IN THE MATTER OF THE BOARD'S INVESTIGATION	)	SPECIAL RELIABILITY
INTO RELIABILITY ISSUES RELATED TO JERSEY	)	MASTER REPORT AND
CENTRAL POWER & LIGHT COMPANY'S	)	ANALYSIS
MORRISTOWN UNDERGROUND DISTRIBUTION	)	
SYSTEM	)	DOCKET NO. EO11090526

Report to the
State of New Jersey Board of Public Utilities
I/M/O the Board's Investigation
Into Reliability Issues related to
Jersey Central Power & Light Company's
Morristown Underground System

February 3, 2012

Prepared by PJ Downes Associates, LLC

Figure 2

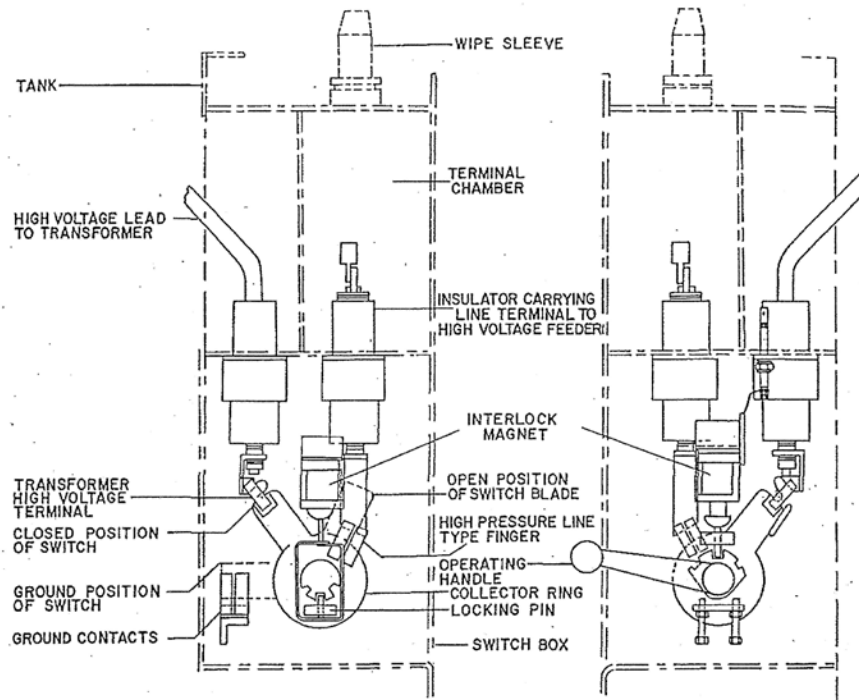
Photographs # 5 and # 6 that were taken by a member of the BPU staff show the failed transformer. It is appropriate that additional preventive maintenance should be conducted on all transformers in the Morristown Network that use a cable termination compartment for connection to the primary circuit.

Initially it will be necessary to identify the number and location of these transformers. The maintenance should include the following items:

1. Sample the oil from the cable termination compartment and test. This will allow data collection regarding any deterioration of the oil up to this time.
2. Drain oil, remove terminal chamber cover, and inspect the compartment and cable terminations for signs of deterioration. If necessary make repairs. Reinstall terminal chamber cover and air test the compartment for leaks. If necessary make repairs.
3. Fill the compartment with Cooper Power System Envirotemp FR3 Fluid or an equivalent dielectric fluid. This is a non-petroleum product with a higher flash point than petroleum based products.

1. Initiate the program and complete refurbishing of transformers with cable termination compartments by June 1, 2012. The Company has agreed to this recommendation.
